Manual Supplement

Manual Title: 753/754 Users
Print Date: July 2011
Revision/Date: 1, 8/12

Supplement Issue: **5**
Issue Date: 12/17
Page Count: 5

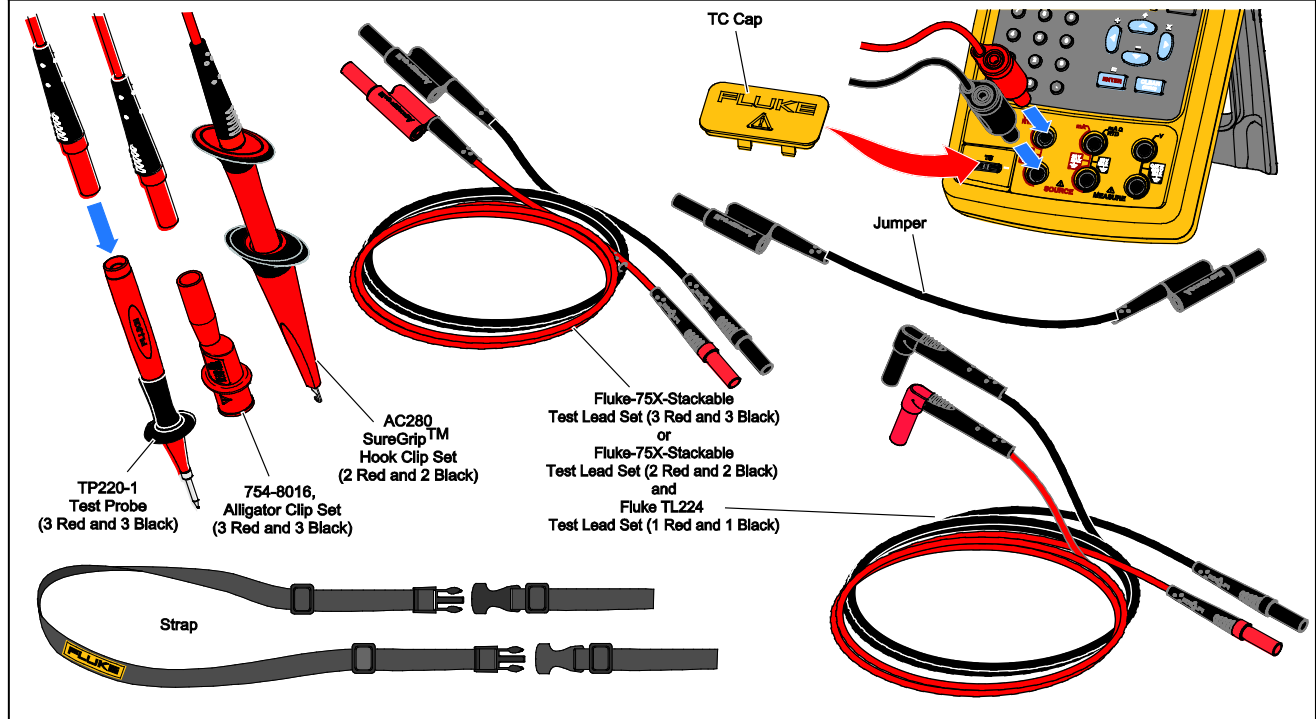
On the Cover add the  **Symbol**.

On page 5, add the following to the **Symbols** table:

<p>Conforms to the Appliance Efficiency Regulation (California Code of Regulations, Title 20, Sections 1601 through 1608), for small battery charging systems.</p>
---	--
